Consultee Comments for Planning Application APP/19/00911

The following comments have been received from Landscape Civil Engineering & Landscape Team at Havant Borough Council on 04/10/2019. Responses to the comments are shown red:

Existing North elevation

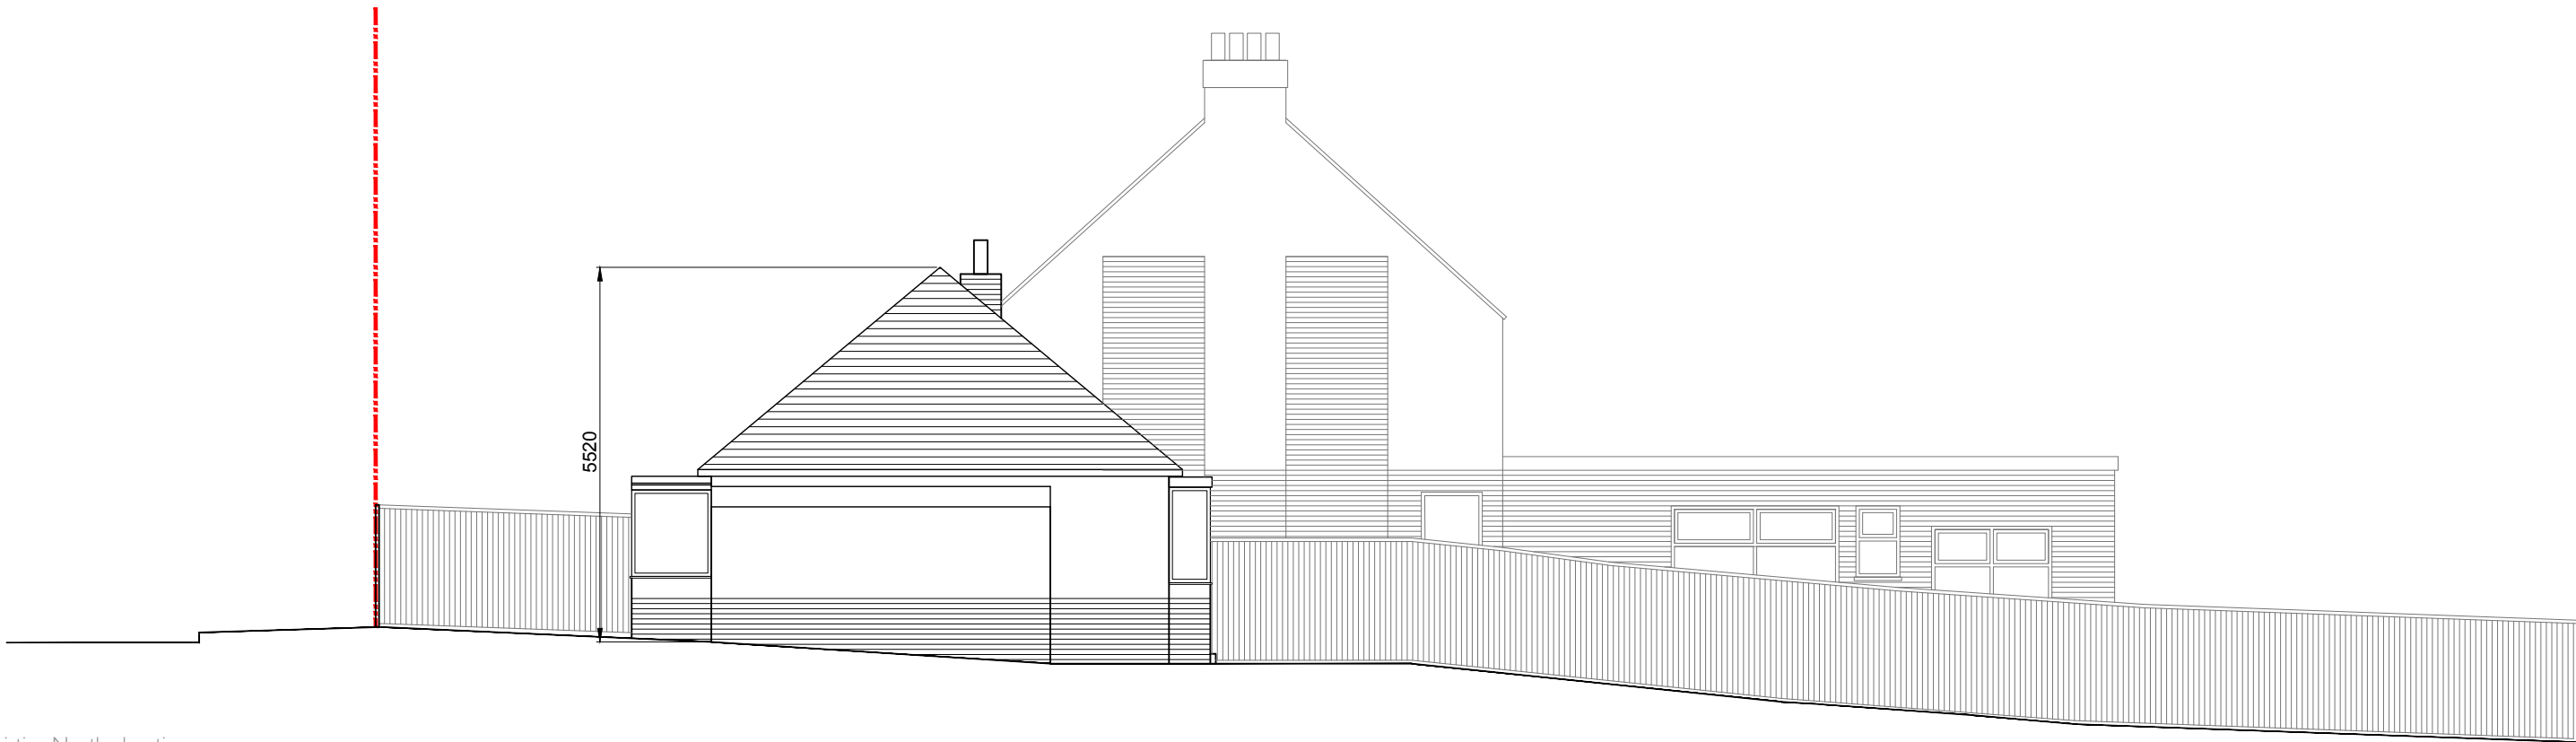
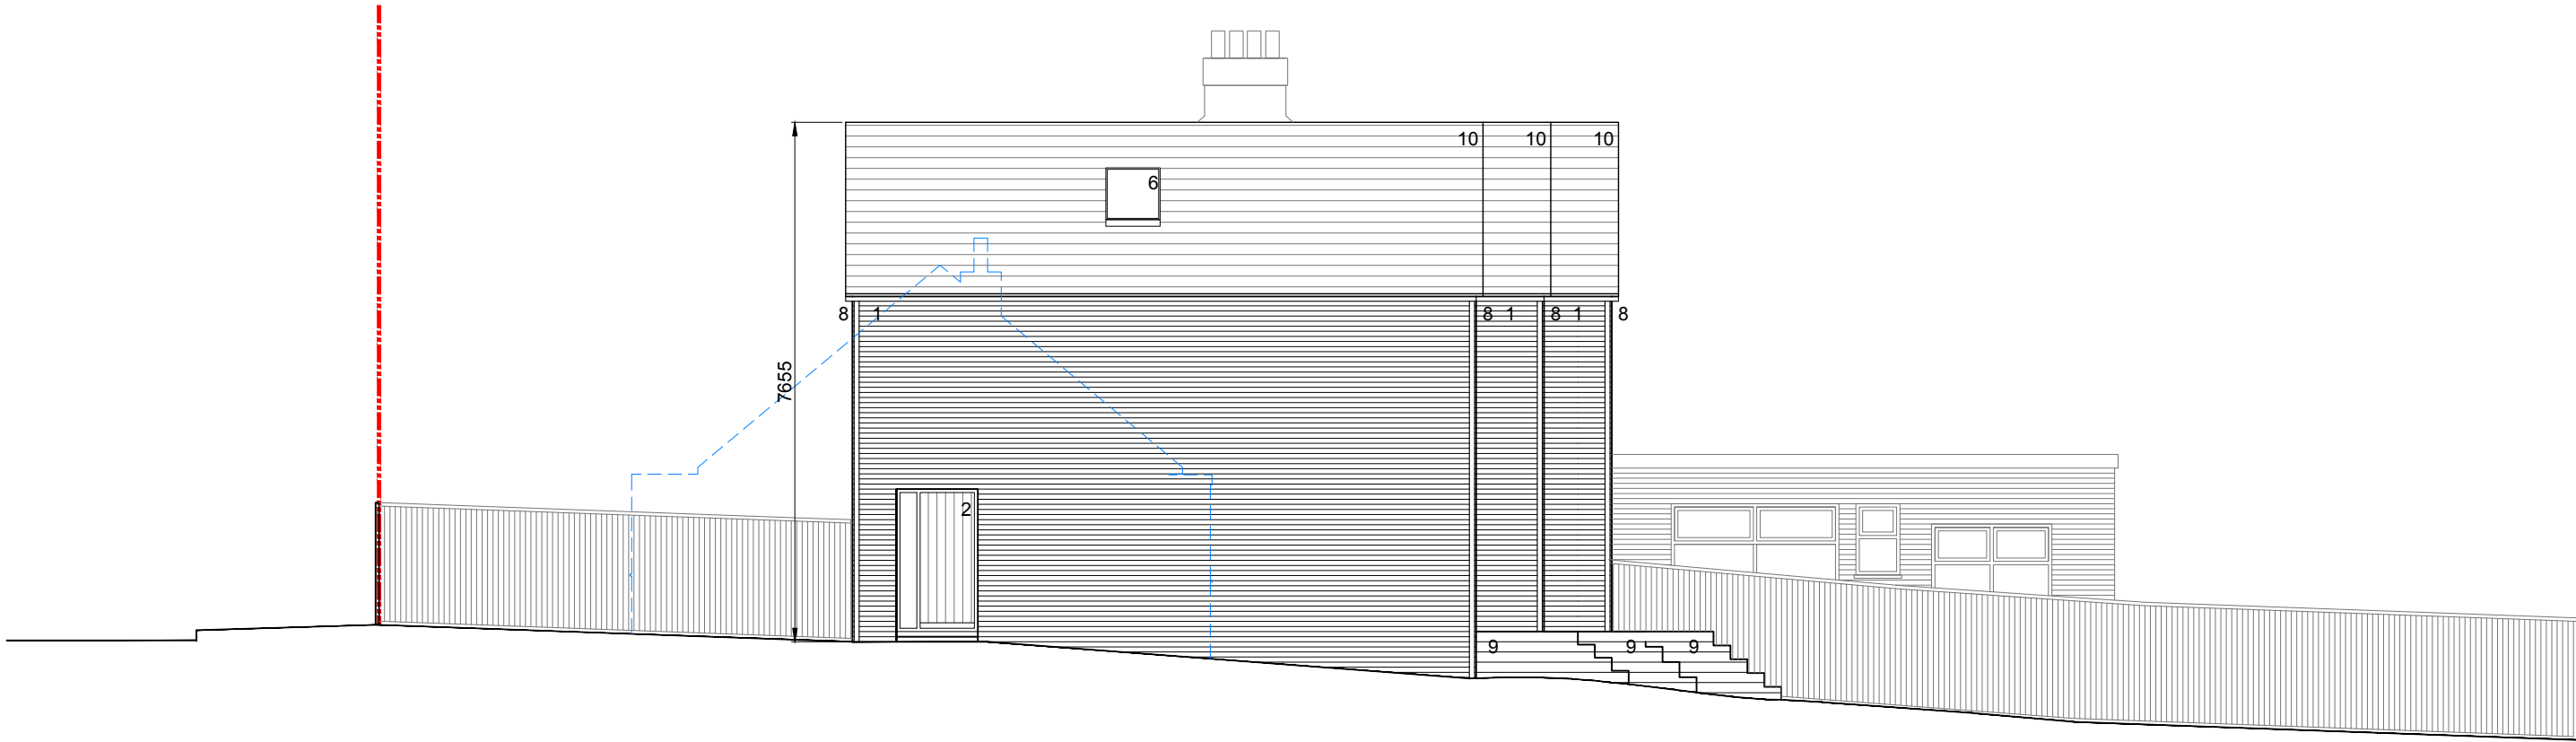
*- “The sloping topography creates a significant level change throughout the site as such we require existing and proposed level data to fully understand the proposals.” Please refer to the attached existing and proposed elevation drawings C0146-P204 & P214 that clearly indicates the change in levels. A full Topographical Survey has been undertaken, indicating the levels of the sloping site.*

Diagram showing turning circles of a car driving into parking bay 1 (shown red) & exiting parking bay 1 (shown black).

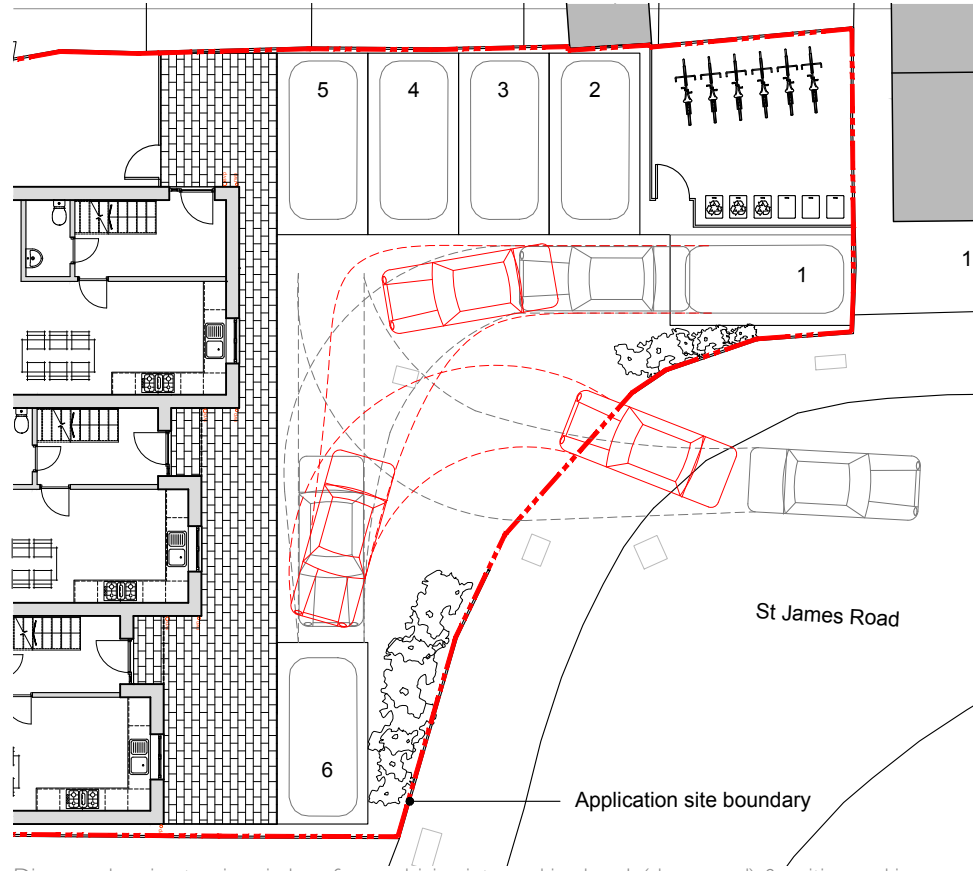
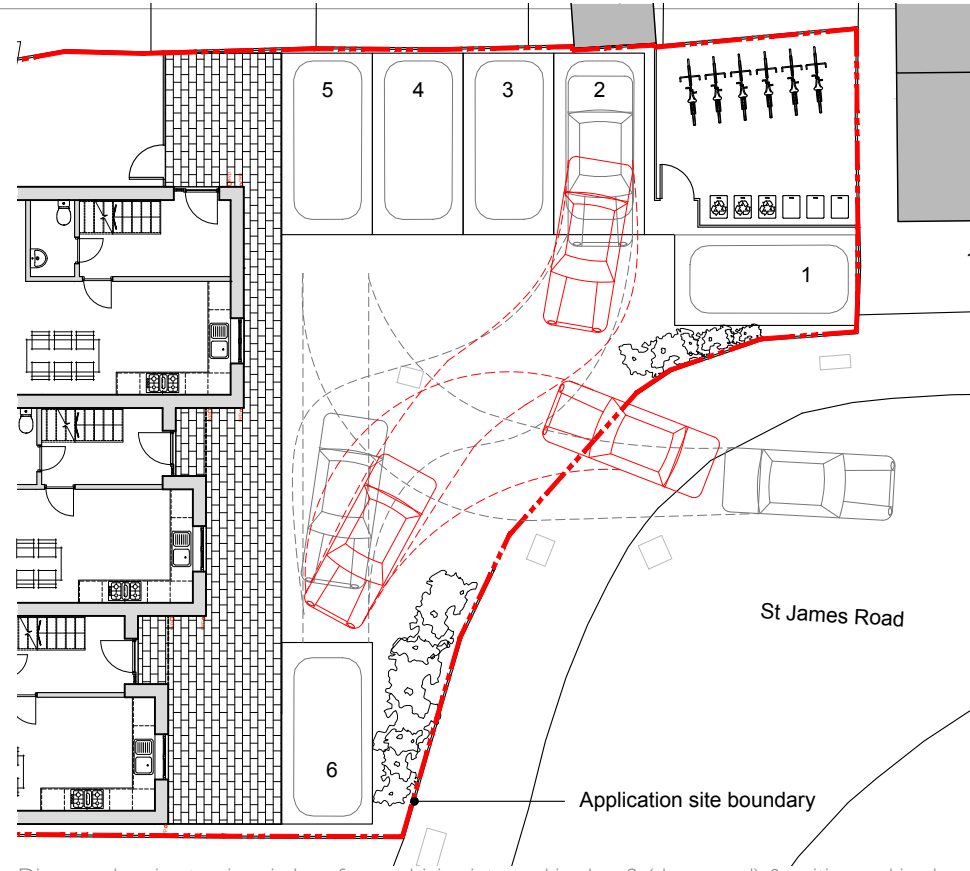
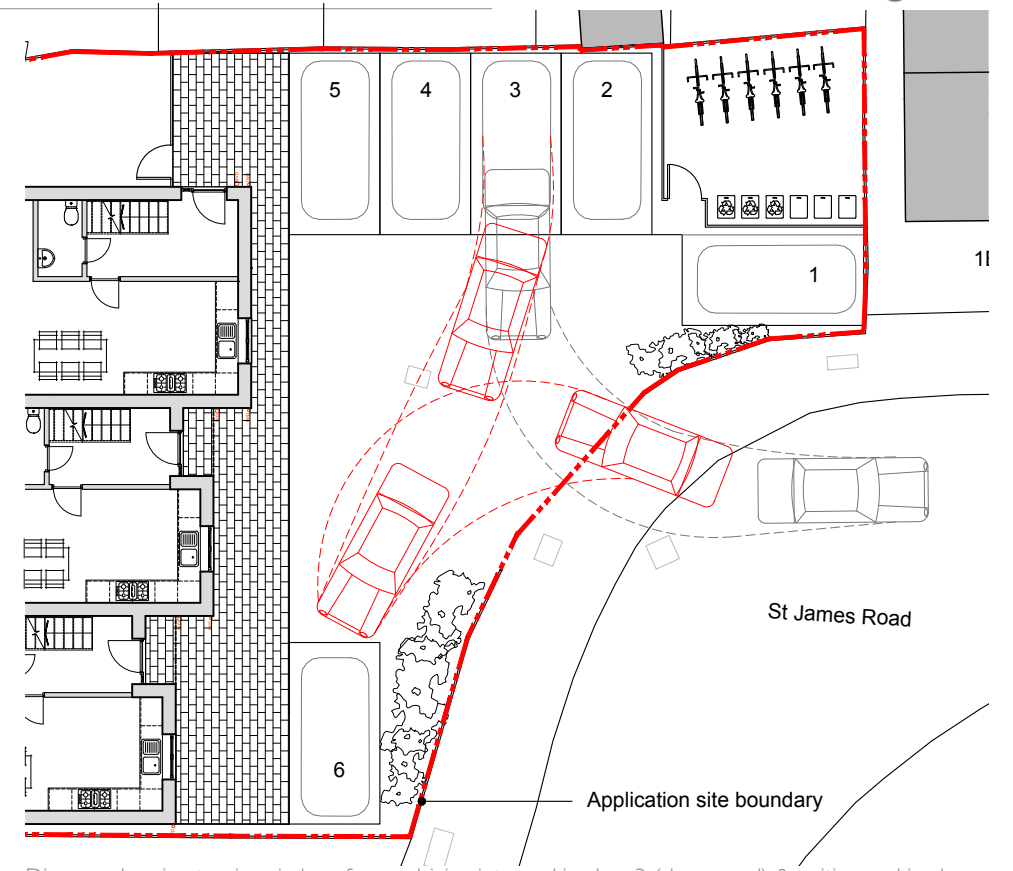
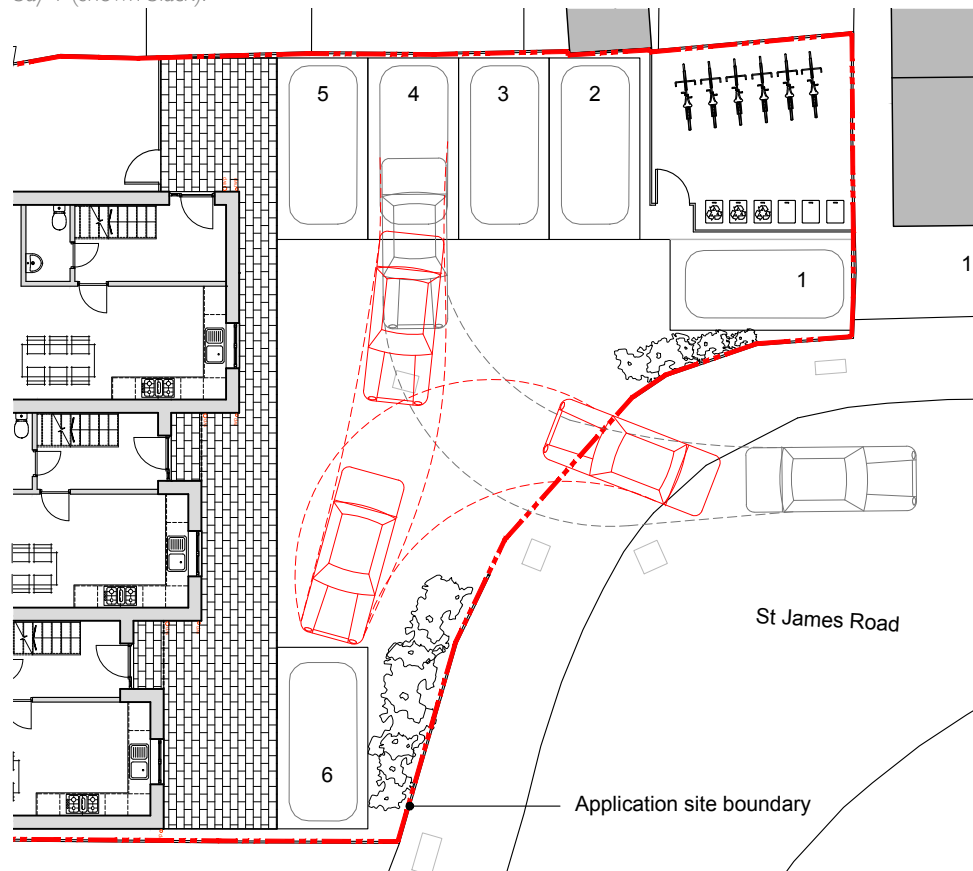
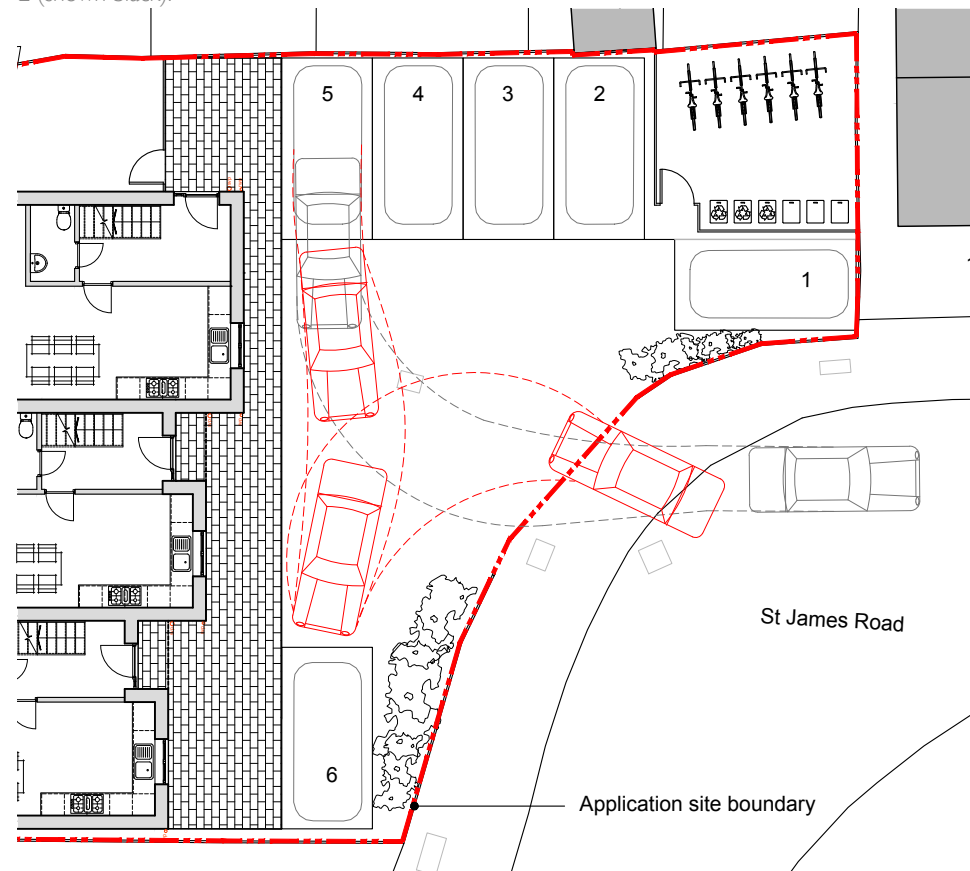
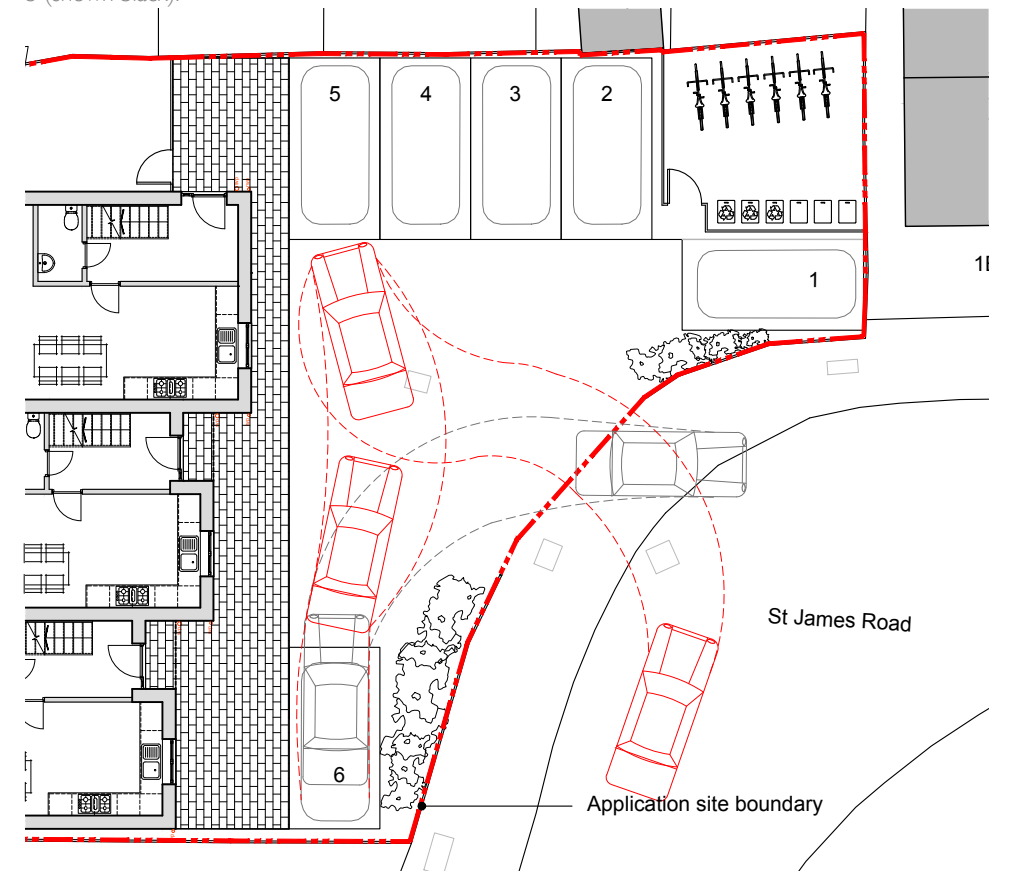
*- “The layout/design for the parking area and frontage to the properties is not acceptable and needs to be redesigned. The accessibility and location of the parking bays for no. 1 in particular do not work. We will require vehicle tracking data on any proposals to ensure the appropriateness of the design.” As indicated on the attached series of site plans, the accessibility and location of the parking bays are compliant, as proven by the turning circles marked on the site plans.*
